# Access Compliance Report

## Public Rights-of-Way

### (Curb Ramps)

Intersection ID: 1002958	Main Street: CANDLE_LEAF_CT	Cross Street: N/A	Location: NW
ADA ID: 9FA942BDD9A9	Ramp Type: BlendTrans1	Initial Pass/Fail: Fail	Overall Compliance: No
		Severity Score: 10

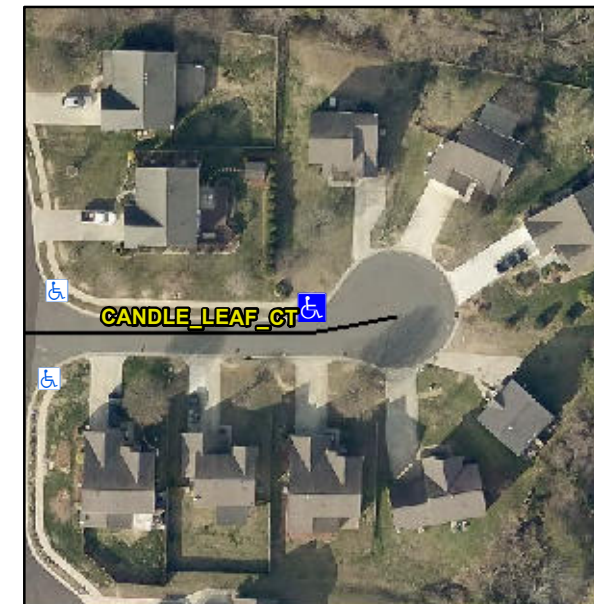
Compliance	Description	Data	Compliance	Description	Data
N/A	Ramp Length (in)	47.0	Yes	BlendTrans Slope (%)	4.2
No	Ramp Width (in)	47.0	Yes	BlendTrans XSlope (%)	2.1
N/A	Flare Type LT	N/A	N/A	Flare Type RT	N/A
N/A	Flare Slope LT (%)	N/A	N/A	Flare Slope RT (%)	N/A
N/A	Flare Traversable LT?	N/A	N/A	Flare Traversable RT?	N/A
N/A	Landing Length (in)	N/A	N/A	DWS Provided?	N/A
N/A	Landing Width (in)	N/A	N/A	DWS Contrast?	N/A
N/A	Landing Slope (%)	N/A	N/A	DWS Length (in)	N/A
N/A	Landing X Slope (%)	N/A	N/A	DWS Full Width?	N/A
N/A	Landing Curb? (Y/N)	N/A	N/A	DWS Offset (in)	N/A
N/A	Shared Landing?	N/A			
N/A	Gutter Ponding?	N/A	N/A	Gutter Slope (%)	N/A
N/A	Gutter Lip Ht (in)	N/A	N/A	Gutter X Slope (%)	N/A
N/A	Painted X Walk1?	No	N/A	Painted X Walk2?	N/A
	X Walk 1 Direction	To S		X Walk 2 Direction	N/A
	X Walk 1 Width (in)	N/A		X Walk 2 Width (in)	N/A
	X Walk 1 Slope (%)	1.4		X Walk 2 Slope (%)	N/A
	X Walk 1 X Slope (%)	4.3		X Walk 2 X Slope (%)	N/A

N/A	Ramp inside XWalk1?	N/A	N/A	Ramp inside XWalk2?	N/A
	Road Slope (%)	4.3		Clear Space?	N/A
	Road X Slope (%)	1.4	N/A	Clear Space to XWalk (in)	N/A
N/A	Any Obstructions?	N/A	N/A	Storm Grate/Utility Hazard?	N/A
	Obstruction Type			Storm Grate/Utility Type	
		N/A			N/A
			Yes	Surface Condition? (G/P)	Good
			N/A	Curb Slope (%)	3.3

**Remove & Replace Curb Ramp With Two New Directional Ramps or Equivalent.**

**R304.5.1**
